CITY OF BOULDER
Community Planning & Sustainability

CITY OF BOULDER
LAND USE REVIEW RESULTS AND COMMENTS

APPLICANT RESPONSES
APRIL 20, 2015

DATE OF COMMENTS: **February 27, 2015**
CASE MANAGER: **Chandler Van Schaack**
PROJECT NAME: **The Commons Armory Community**
LOCATION: **4750 BROADWAY**
COORDINATES: **N09W06**
REVIEW TYPE: **Site and Use Review**
REVIEW NUMBER: **LUR2015-00012**
APPLICANT: **BRUCE D DIERKING**
DESCRIPTION: **SITE AND USE REVIEW (COMPLEX) - "The Armory Community" - Proposal to subdivide into four blocks, through a two-phased process. Phase I includes blocks 1 & 2, comprising the western portion of the site, to include preservation and adaptive re-use of the existing Armory Mess Hall, together with construction of three new buildings with subgrade parking and surface plazas. Phase II includes blocks 3 & 4, comprising the eastern portion of the site, to include 45-65 residential units.**

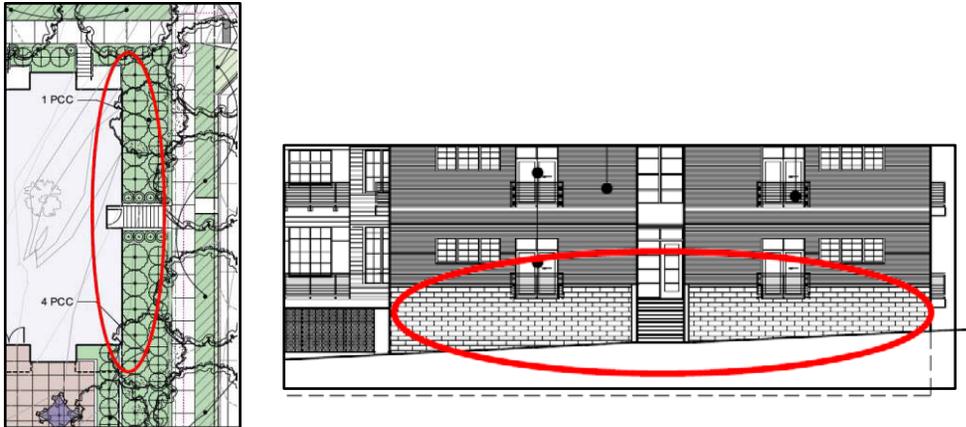
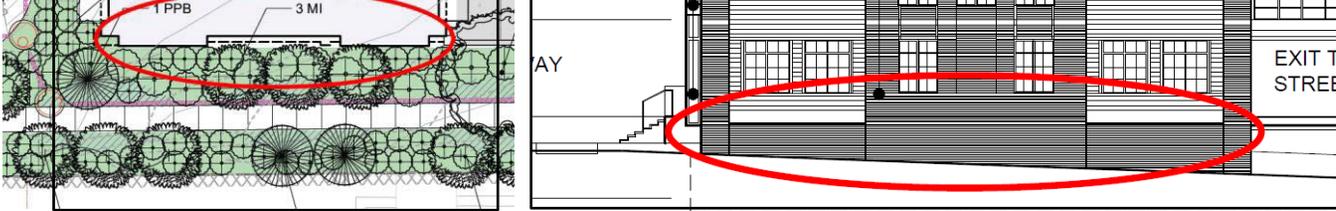
10. The same concerns exist for building D (east and south elevations). Evaluate alternative building design and fully detail the adjacent landscape.

The east and south elevations of building D have plants specified. Refer to the landscape plans. Also, the elevations have been revised to reflect a response to comments made by staff and include enhancement of these facades.

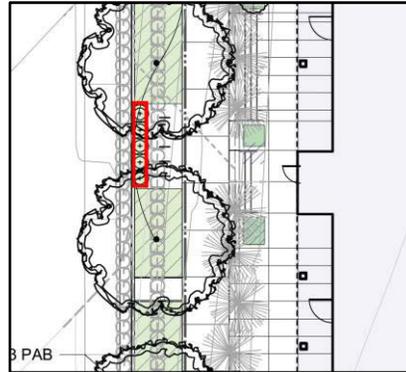
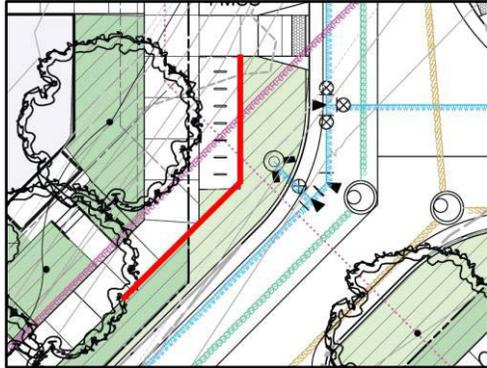
14. The Broadway parallel parking pedestrian connections seem to lack some connections to the north.
Connections have been added.
